Duplex Coverage Estimates for Selection of TP3 Stressors

Comments: 196, 201
Proposed Remedy: Reject

Purpose: contribute to task force resolution of comments 158, 196, 199, 200, 201, 219-221, 401, and 402

Duplex Link Coverage Calculations (γ=0.95 example)

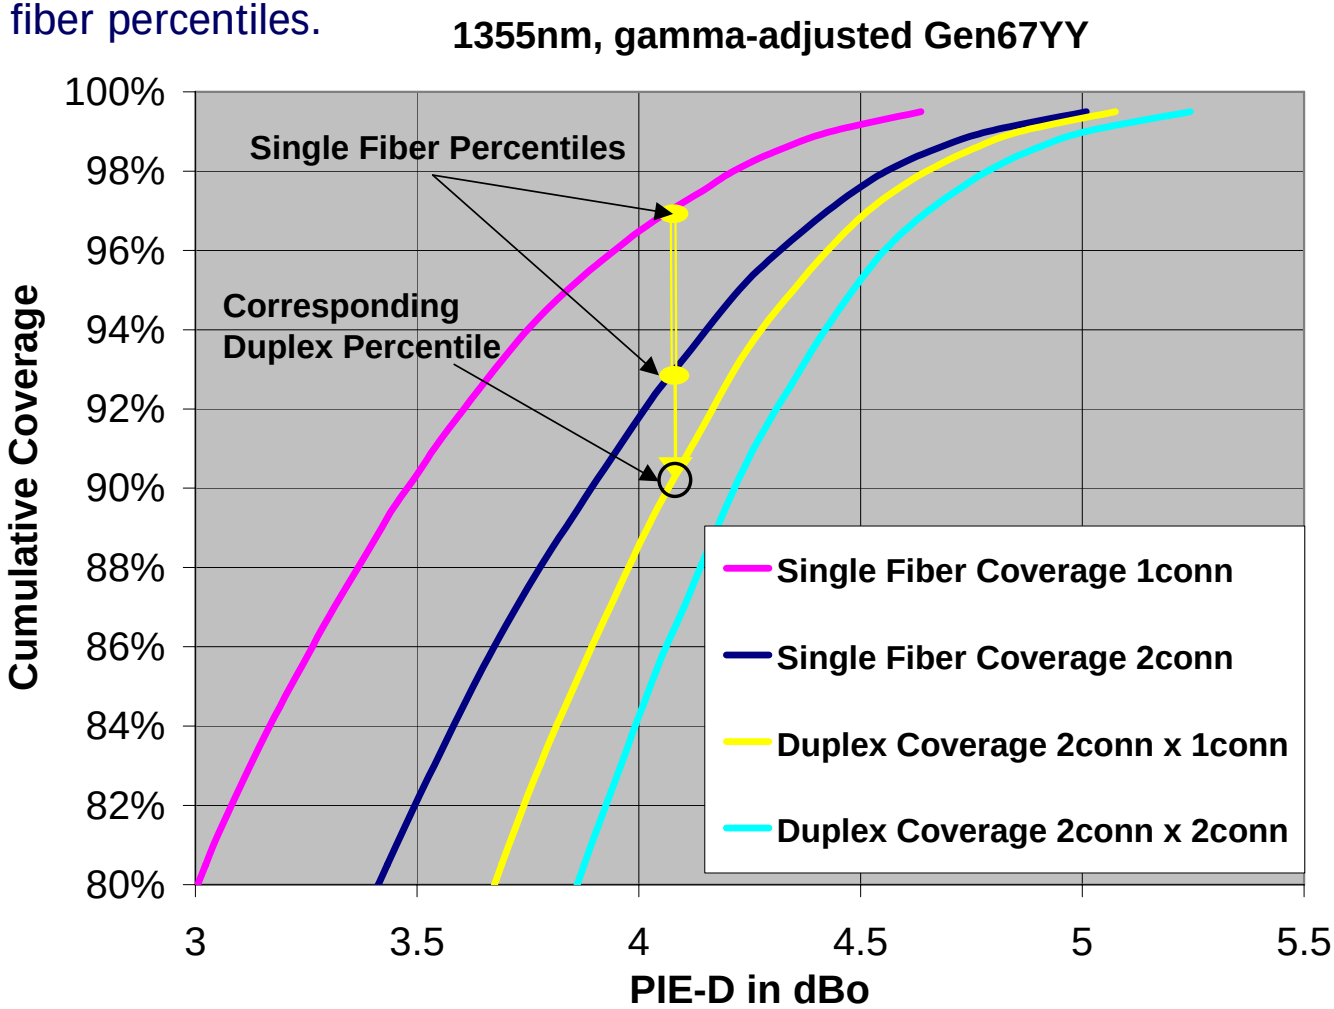
- For the case of 2 connectors between transmitter and fiber in both directions, one should square the single-fiber percentile
- For 2 connectors in forward direction, it is most common to have 1 connector in the reverse direction. Then one should multiply together the 1-connector and 2-connector single fiber percentiles.
